Field Safety Notice related to exoplan

Customer information for patient safety for the safe use of exoplan, our software for implant planning and surgical guide design.

3.0 Galway	4260521365019
	3.1 Rijeka	4260521365026
Type of treatments	Planning of fully-guided cases using <i>Bicon implant</i> , <i>Bicon sleeve</i> , and <i>Bicon kit</i> libraries	
Affected library	The issue is an incorrect compatibility information contained in library <i>Bicon_sleeve</i> suggesting the usage of a drill that is 2mm too long.	
Involved dental parts and tools	Bicon® - MAX 2.5™ Integra-CP™ Ø 4mm, L 6mm implant, article number: 260-340-256 Bicon® - Guided Surgery Sleeves, Fully Guided, 4.0 Bicon® - 4.0mm Guided Surgical Kit, Ø 4mm, L 8mm, article number: 260-940-380	
Involved exoplan libraries with part from external manufacturers	Cases planned and designs of surgical guides with the following exocad libraries: <ul style="list-style-type: none"> • <i>Bicon_MAX25_plan_fda</i>, using implant Ø 4mm, L 6mm, article number 260-340-256 in combination with <ul style="list-style-type: none"> - <i>Bicon_sleeve</i>, and - <i>Bicon_4.0mm_kit</i> The version of the library can be identified by the tag <Signat

Figure 1: Display of critical combination of items at the exoplan user interface

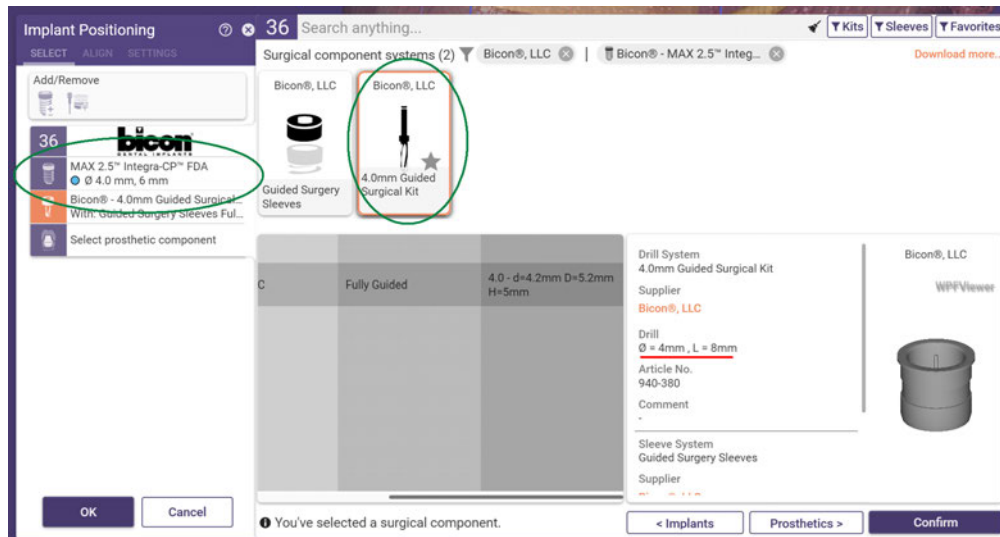
What have we found?	During an update of data used in a library shipped with exoplan or made available on the download portal of exocad, it was found that the use of a specific combination of an implant, sleeve and drill in a surgical kit can result in a hole being drilled for the implant 2mm too deep.	
What might go wrong?	In case an implant 260-340-256 of Bicon with a 4mm diameter and 6mm length is used in a fully-guided surgery procedure using a 4mm diameter Bicon sleeve it should only be possible to select a drill with 6mm length. But erroneously uses an 8mm length drill (instead of 6mm length drill) from the surgical kit. See figures 1 and 2. Possible impact on patient health: During surgical alveolar implant preparation and positioning 2mm lower than planned and expected surrounding anatomical structures can be damaged, including nerves and blood vessels, causing bleeding,

Figure 1: Critical combination of items, 4.0mm, L 6mm Implant using a 4.0mm Guided Surgical Kit, results in an automatic selection of a drill with 8mm length.

Figure 3: Unsigned library message to user

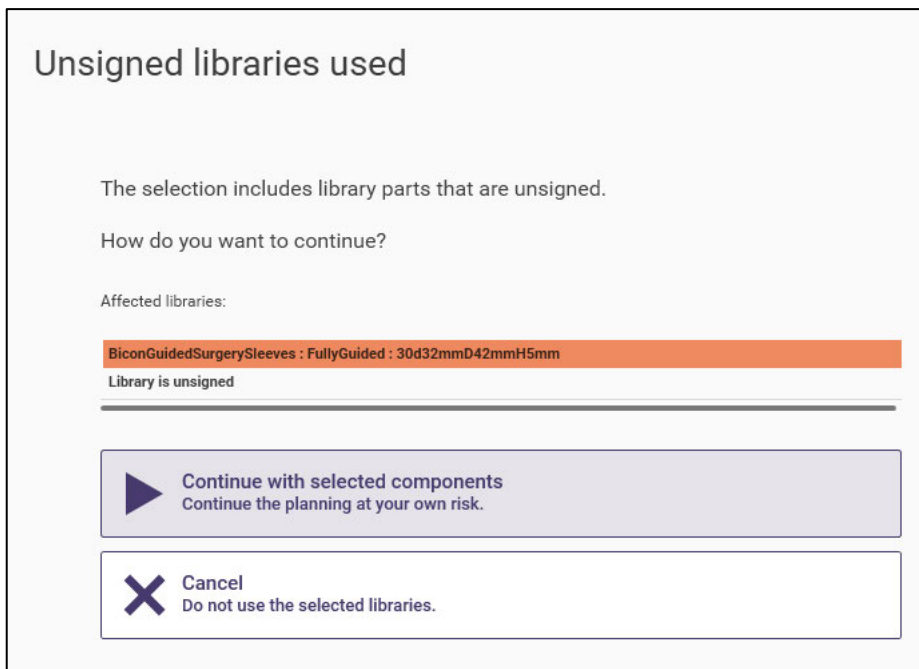
Figure 3: Unsigned message to user. Users notified by this warning should click “cancel” and not “continue”.

Figure 4: Downloading an updated library

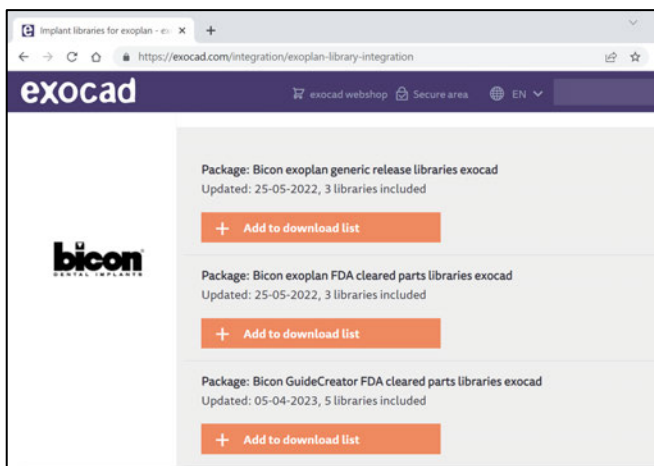
Figure 4: Downloading libraries with corrections from the exocad download portal.

<p>Impact on other implant component combinations</p>	<p>Other combinations of libraries, surgical kits and implants than the above-mentioned are not affected by the found issue, nor is any other issue known for other combinations.</p>
<p>Patient injury</p>	<p>exocad has no known information relating to any patient injury that has happened in such case.</p>
<p>Actions</p>	<p>Users that are affected by the described issue are to be notified that:</p> <ol style="list-style-type: none"> 1) The subject <i>Bicon Sleeve</i> library containing erroneous compatibility information about implant, drill and sleeve was “blacklisted” on the exocad server on 3 April 2023. By that, the library defect is not available for new designs of surgical guides for existing and future installations. The user receives a message indicating that a library in the planning is “unsigned” (see figure 3). Users notified by this warning should click “cancel” and not “continue”. 2) The library defect was corrected by exocad. 3) The corrected library was made available on exocad’s download portal, see https://exocad.com/integration/exoplan-library-integration <p>End users that want to use the above libraries or plan Bicon implants in a fully guided procedure should download the corrected versions of the following library packages:</p> <ul style="list-style-type: none"> - Bicon GuideCreator FDA cleared parts libraries exocad <p>Or use this download link: https://exocad.com/downloads/exoplanlibraries/BI_Bicon-GuideCreator-FDA-cleared-parts-libraries-exocad.zip (see also figure 4)</p>
